### REMARKS

Applicants have studied the Office Action dated May 23, 2005, and Claim 19 has been amended for grammatical purposes only. No new matter was added. Claims 1-19 remain pending in the application. Reconsideration and allowance of the pending claims in view of the following remarks and arguments are respectfully requested. Applicants submit that the application is in condition for allowance. In the Office Action, the Examiner:

10/763,044

Fig. 2

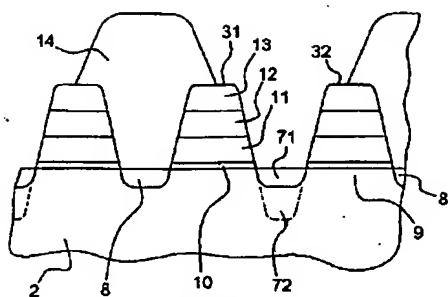
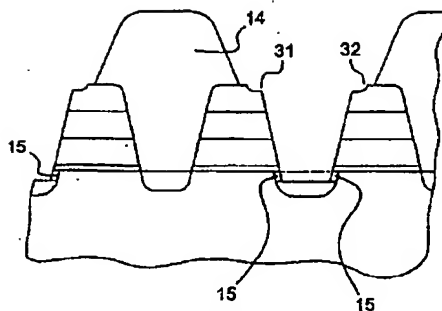
Nowhere does Subramanian teach an attack of a material located under the precursor stack or the presence of a residue from a previous attack. As shown by the FIGs. 2 and 3 of the present invention below, the formation zone and the protective resin 14 are attacked resulting in a deposit of residue 15 from the protective resin 14 below the precursor stacks 31, 32.

Nowhere does Subramanian teach a deposit of residue 15. Column 7, lines 26-29 of Subramanian cited by the Examiner merely state that the portions of the field oxide regions and the gate dielectric layer between every second pair of adjacent stacked gate structures in the array core are typically removed in preparation for the formation of the common line CS. This is not the same as "an attack of the formation zone and of the protective resin so as to result in a deposit of residue from the protective resin below the precursor stacks", as recited for claim 1. Accordingly, the present invention distinguishes over Subramanian for at least this reason.

FIG. 2C (PRIOR ART)

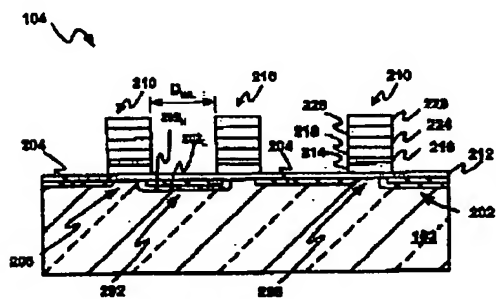
The Examiner points to elements 212 of FIG. 2C and element 318 of FIG. 6 in Subramanian and compares them to the protective resin 14 of the present invention, which is illustrated in FIG. 2 and FIG 3 above. As stated above, Subramanian explicitly teaches that element 212 and 318 are dielectric layers, not protective resins as recited in the claimed invention. Additionally, FIG. 2C of Subramanian teaches that the dielectric layer, which is part of the stacked gate structure 210 (See column 5, lines 39-40), is first deposited then the stacks 210 and the layers of the stack 210 are formed. For example, Subramanian teaches at column 6, lines 31-37 that the dielectric layer 212 is initially formed on the substrate 102 then a layer of conductive polysilicon is formed on top of the dielectric layer 212. Additional layers are then added.

The dielectric layer 212 of Subramanian is below the stack 210; however, this layer is deposited on the substrate before any of the other layers of the stack 210 are deposited. The present invention, on the other hand, recites "an attack of the formation zone and of the protective resin so as to result in a deposit of residue from the protective resin below the precursor stacks". In other words, the precursor stacks are already in place when the residue is deposited below the precursor stacks.

Additionally, as stated briefly above, the Examiner compares element 212 of FIG. 2C and element 318 of FIG. 6 of Subramanian to the protective resin 14 of the present invention. The Applicants respectfully point out that element 212 of FIG. 2C and element 318 of FIG. 6 of Subramanian are not the same as the protective layer 14 of the present invention. Elements 212 and 318 of Subramanian are dielectric layers. See column 7, lines 24-25 and lines 59-60 of Subramanian.

Furthermore, the Examiner states that layers 212 and 318 are the same as the protective resin 14 in the present invention. Therefore, Subramanian would have to teach that layers 212 and 318, which are dielectric layers, are removed after implantation of the source line. As can be clearly seen from FIG. 2C, the source line exists and the layer 212 also exists. Accordingly, Subramanian does not teach, anticipate or suggest "removing the protective resin following implantation of the source line".

FIG. 6

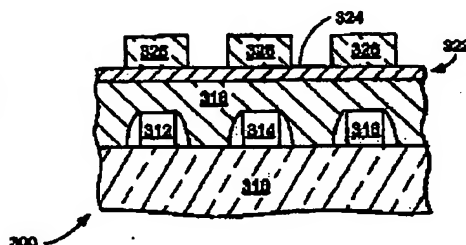
Furthermore, layer 318 is not at any point formed below precursor stacks. Layer 318, which is a dielectric layer, is below an ARC layer 322, which is below a photoresist 326, not a precursor stack. Accordingly, the present invention distinguishes over Subramanian for at least these reasons as well.
